STAFF REPORT: FEBRUARY 11, 2026 MEETING

APPLICATION NUMBER: HDC2026-00019

ADDRESS: 1656 W BOSTON BLVD

SCOPE: DEMOLISH GARAGE*, ERECT GARAGE

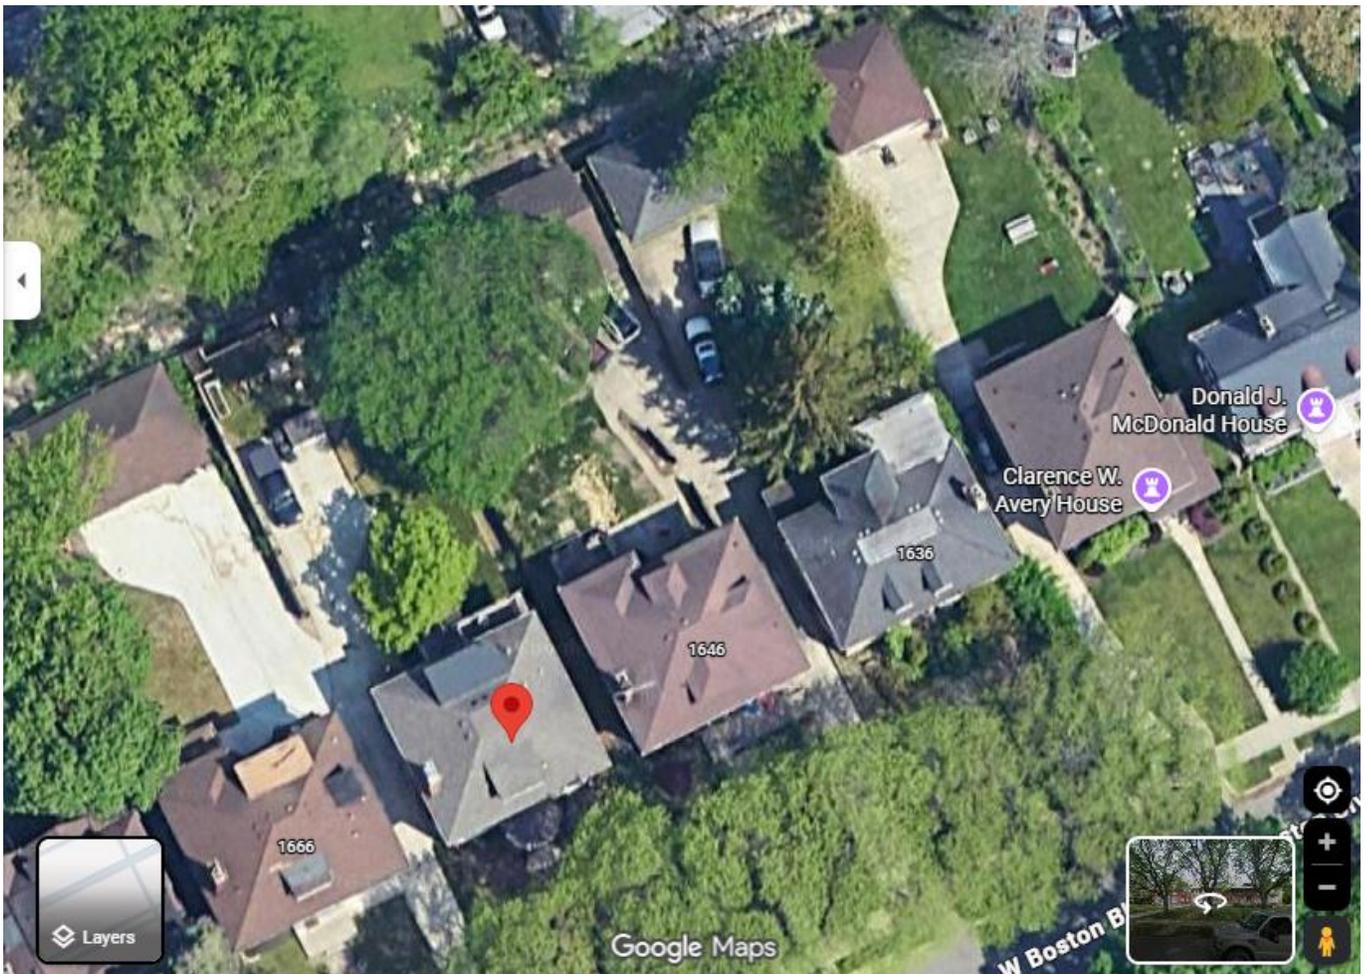
- To gauge compatibility, staff looked at existing garages on the same block of W Boston. Most of the garages have doors that face W Boston, but a couple face the alley, and the corner houses at the opposite ends of the block face their respective side streets (the garage behind 1600 faces Woodrow Wilson and the garage behind 1756 faces Rose Parks Blvd). *See the map and the analysis in the table below.*

Staff also looked at present-day (2026) Google Map Views to look at current garage sizes and compare to the proposed garage.

<i>Address</i>	<i>Garage Size/Description</i>	<i>Other Notes</i>
1600 W Boston Blvd	Slightly deeper than a square historic garage and about 1/3 wider.	Garage faces Woodrow Wilson St. and matches Tudor style of house.
1616	Northeast corner has a historic garage that appears to be about the size of a two-car garage.	Garage has wood siding painted white.
1626	Square historic garage.	Wood siding.
1636	Square historic garage.	House is brick with some stucco and garage is stucco with historic wood doors.
1646	Roughly the same width as the square historic garages, but slightly deeper.	Rectangular with gabled roof, brick with paneled wood door, similar to house materials and style.
1656	Subject property —proposed garage is about as deep as a historic square garage but	Cementitious lap siding proposed.

about 50% wider.	
1666	Roughly the same depth as the square historic garages, but twice as wide.	In 2022 Google Street View, front of garage is faced with brick and has white doors and white trim to match house. Site visit documents a stucco garage here.
1676	Size is hard to estimate.	Historic stucco garage.
1686	About the same size as a square historic garage.	Historic wood-sided garage.
1694	Same depth as square historic garage, but a few feet wider.	Brick Tudor house, with matching brick garage.
1706	Size is hard to estimate; seems similar to 1694's garage.	Brick Colonial Revival house, matching brick garage.
1716	--	Brick, stucco, half-timbering house. No garage visible on Google Street View. At site visit, there are three brick garages and then the buff brick garage, so this house may not have a garage.
1726	Same depth as a square historic garage, but about 20% wider.	Brick Colonial Revival house with matching garage.

1736	Square historic garage.	Buff brick Craftsman house with masonry "stitching" on bay window. Matching buff brick garage.
1746	Same width as a historic square garage, and about 10% deeper.	At site visit in 2026, brick house, but next visible garage from alley is buff brick, so this house may not have a garage.
1756	Same depth as a square historic garage, and about 30% wider.	Garage faces Rosa Parks Blvd. Brick Tudor home with brick garage with Tudor detailing.
